Current Zoning: N1-A (Neighborhood 1-A)
Proposed Zoning: N2-A(CD) (Neighborhood 2-A, Conditional)

Approximately 19.54 acres located east of Mallard Creek Road, on the north and south side of Alexander Road, and along the west side of College View Lane.

The petition proposes a residential development of up to 195 multi-family attached units. The site has existing single family development.

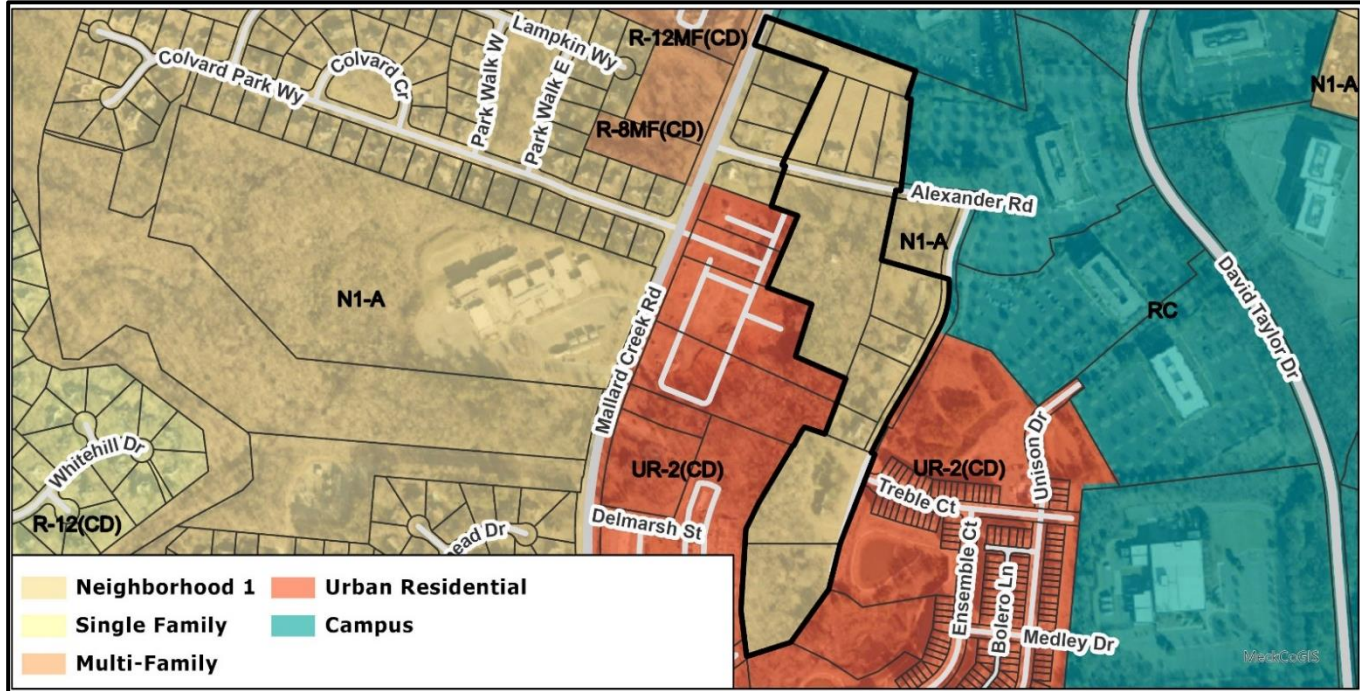
1. Revise roadway callouts to be U-03 and not U-03A1. U-03A1 is simply one part of the overall layout of U-03 while U-03 describes all of the U-03 cross sections required for this site.

2. Revise roadway callouts to be U-03 and not U-03A1. U-03A1 is simply one part of the overall layout of U-03 while U-03 describes all of the U-03 cross sections required for this site.

3. Add proposed ROW dimensions to the site plan for College View Lane and Alexander Road. Ensure ROW is dimensioned in relation to the roadway centerline.

4. Revise site plan by revising callout to say final design of Treble Court connection to College View Lane to be coordinated during permitting.
5. Revise roadway identifier on the site plan to callout roadway as proposed, due to this not currently existing.

6. The existing R/W does not exist connecting to Silver Branch road. Label that the R/W and street will be constructed and improved along the entire project boundary.

7. Label the 8' sidewalk and 8' planting strip on all public streets. Label the centerline and the distance from centerline to 2' behind the sidewalk as R/W.

8. Ensure that tree save meets all standard. Tree save has a 10' no build zone around it and does not permit sidewalks within tree save.
9. Some areas shown as tree save do not have any trees. Adjust tree save areas to include existing canopy.

| 10. Clarify the provided seating requirements for public open space. |
